KITSAP TRANSIT NORTH BASE MAINTENANCE FACILITY CONDITIONAL USE PERMIT AND SITE PLAN REVIEW

To: Heather Wright, Poulsbo Planning and Economic Development Director
From: Edie Berghoff, Senior Planner
Date: April 15, 2025
Subject: Kitsap Transit North Base Maintenance Facility Conditional Use Permit and Site Plan Review
 Type III Application

**KITSAP TRANSIT NORTH BASE MAINTENANCE FACILITY CUP AND SPR
PLANNING FILE P-07-24-24-02**

Building height:

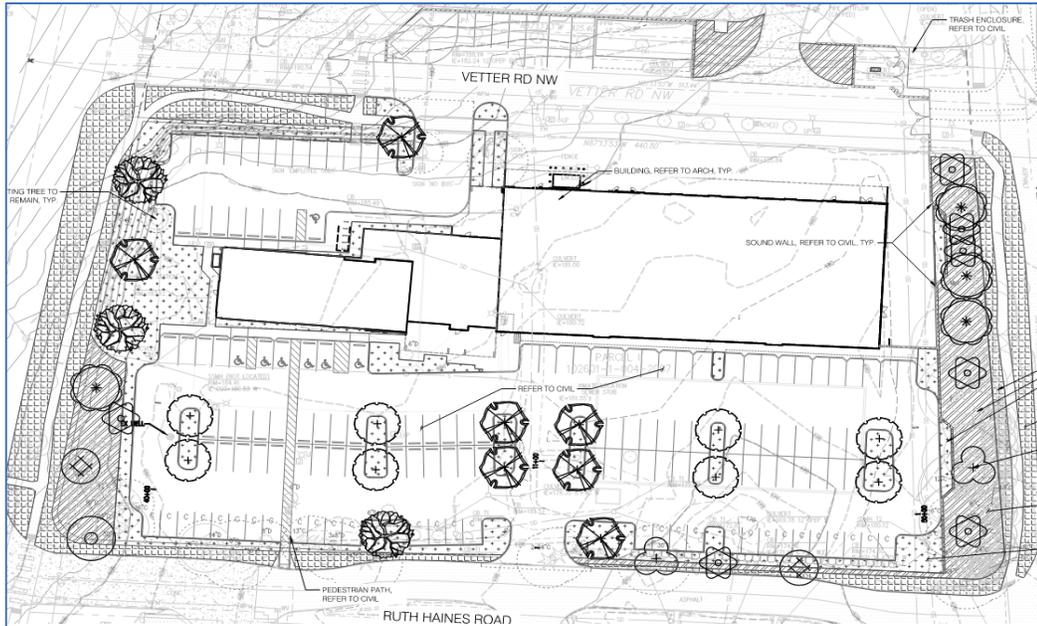
- Building height is 31.6 feet measured according to PMC 18.150.050.
- East and west elevations, measured from finished grade to the highest peak, are 35 feet.
- North elevation is 3 segments, measured from finished grade to roof ridge, provide an average 27.71 feet height.
- South elevation is 3 segments, measured from finished grade to roof ridge, provide an average 28.71 feet height. The east segment finished grade is lower by 3 feet which provides a taller average elevation.
- Heights are summed, divided by 4, providing the average building height of 31.6 feet.

Exterior from Viking Avenue NW (west)

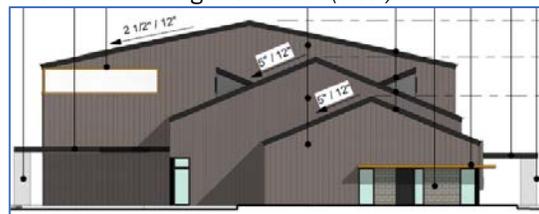
Staff Comment. Sloped roof caps the three distinct building segments. The center section is enhanced with shed dormers and windows facing north and south. The east section upper wall includes clearstory window at the upper roofline and wrapping most of the building segment. Canopies provide shelter at office doors, commons area and over vehicle and person access at the maintenance segment.

West façade shows slope roof of three distinct building segments. Shed roof dormers are visible on the center (operations) segment of the building, (Exhibit E, Design Review)

Exterior from NE Vetter Road (north)

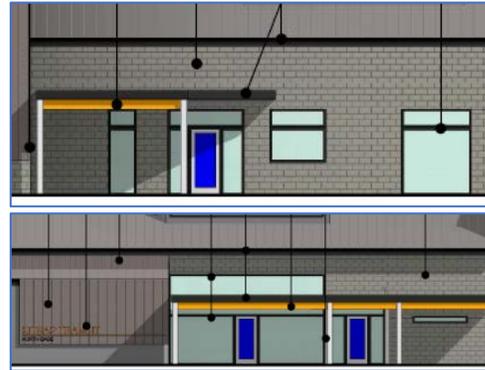
Vehicle doors are further enhanced with upper windows providing natural light to the interior and solid lower panels. Maintenance segment person doors are solid with sidelight, transom window and covering awning.

Portion of north façade shows vehicle doors, person doors and covering awnings. (Exhibit E, Design Review)

Exterior from NW Ruth Haines Road (south)

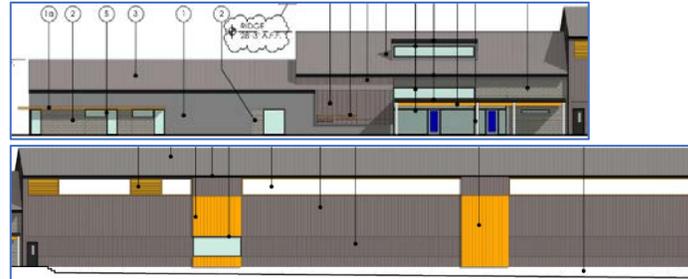
Other building elements such as person doors, awnings, clearstory windows and materials are consistent with fuel and wash buildings north.

Top: Operations and office (west). Bottom: Maintenance (east) (Exhibit E, Design Review)

Building Entrance Facing North

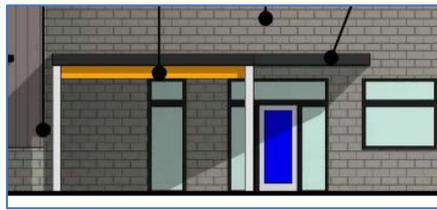
A second building entrance faces the bus parking property which provides pedestrian connection to Viking Avenue NW and access to the bus parking property. The entrance includes a canopy covered outdoor area with supporting pillars, storefront doors in an enclosed vestibule with metal framing and a fascia under the covering canopy is in accent color.

Dumpster enclosure plan. Sound barrier wall highlighted orange. (Exhibit D, Site Drawing)

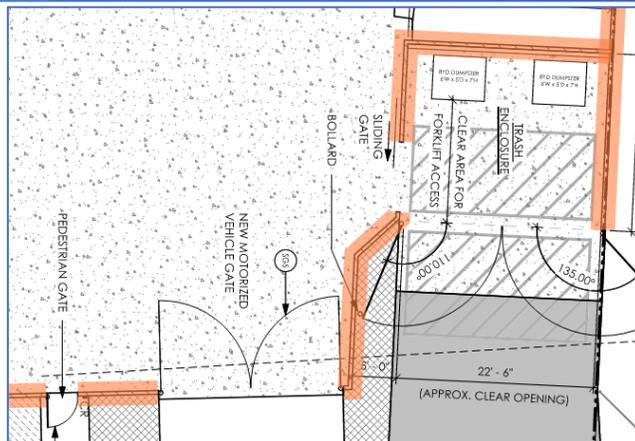
Staff Comment. Solid waste enclosure is in the northeast corner of the project. Placement and design are determined accessible by City Public Works staff for collection vehicles. Enclosure will be surrounded by the sound wall, with two access gates.

Visible from Vetter Road NE an external double gate “will be constructed of steel framing and skinned with a solid panelized material which will minimize gaps where sound might leak through ... the exterior side of the gates will be complementary to the wall using a finish material that will simulate natural wood or a similar color and aesthetic”. (Exhibit B, Project Narrative). All external gates facing Vetter Road NE will be same appearance and construction. (Condition S2).

Left: Exterior wall mount lighting. Right: Typical 20 feet tall light pole. (Exhibit G, Lighting Plan)

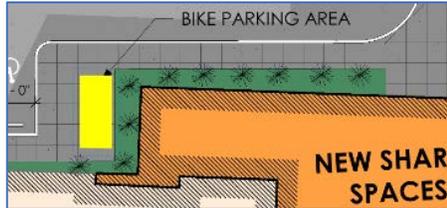
Staff Comment. All exterior lighting is required to be recessed when in exterior canopies or hooded directing illumination downward when on building or pole. A site lighting and photometric plan is provided with the application (Exhibit G, Lighting Plan)(Condition P9).

- P9. All exterior lighting shall be pointed downward and shielded from direct observation from the air, adjacent properties, and public rights-of-way. Lighting under canopies must be recessed. Lighting shall meet all standards identified in the PMC. The applicant shall include a final lighting/photometric plan, including specification of fixtures, at the time of Tree Cutting and Clearing (TCC) permit submittal.
